CALL NO. 101  
CONTRACT ID NO. 141219  
ADDENDUM # 1

Subject: Meade County, DPR 0058 (023)  
Letting April 25, 2014

(1) Revised - Plan Sheets - R1 & X2-X11  
(2) Revised - Bid Items - Page 76 of 76

RIVERPORT ACCESS ROAD EXTENSION  
COUNTY OF  
MEADE

| MEADE     | 4-134.10 | R1        |

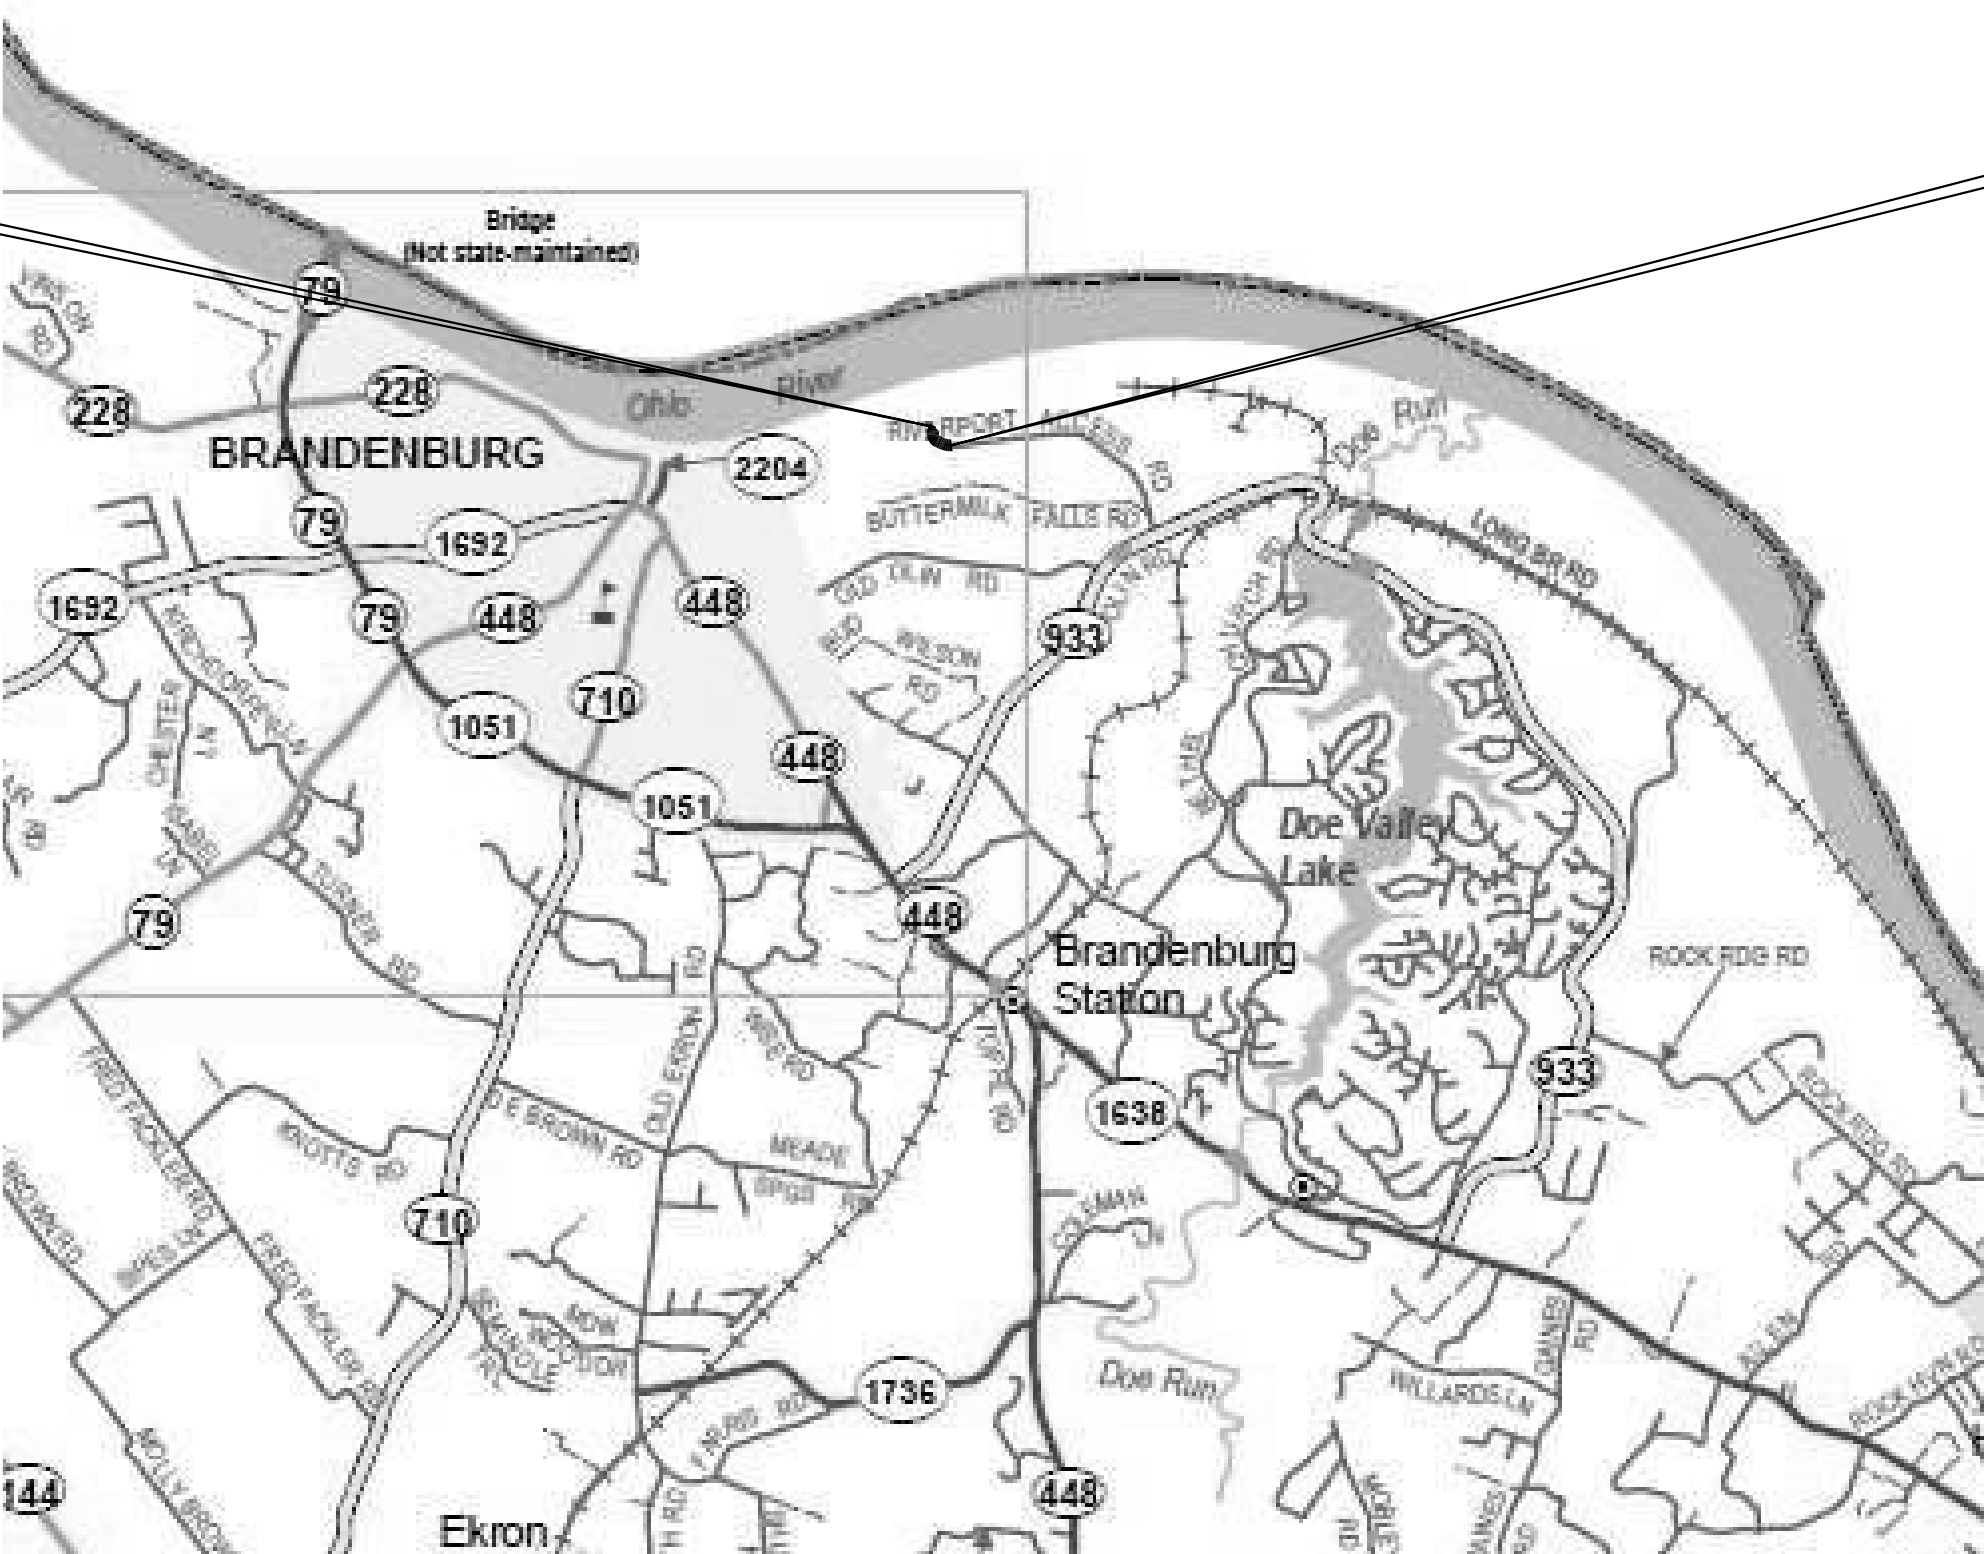
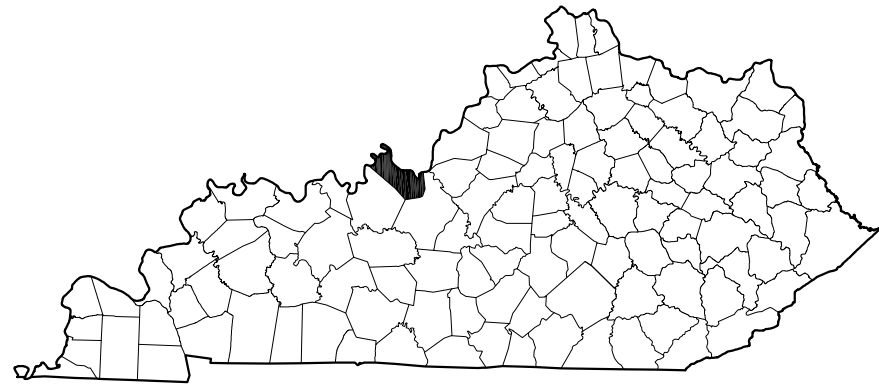
| GENERAL SUMMARY                                                        |                             |      |                |
|------------------------------------------------------------------------|-----------------------------|------|----------------|
| 2200                                                                   | Roadway Excavation          | CY   | 8187 (1)       |

REVISED 04-15-2014
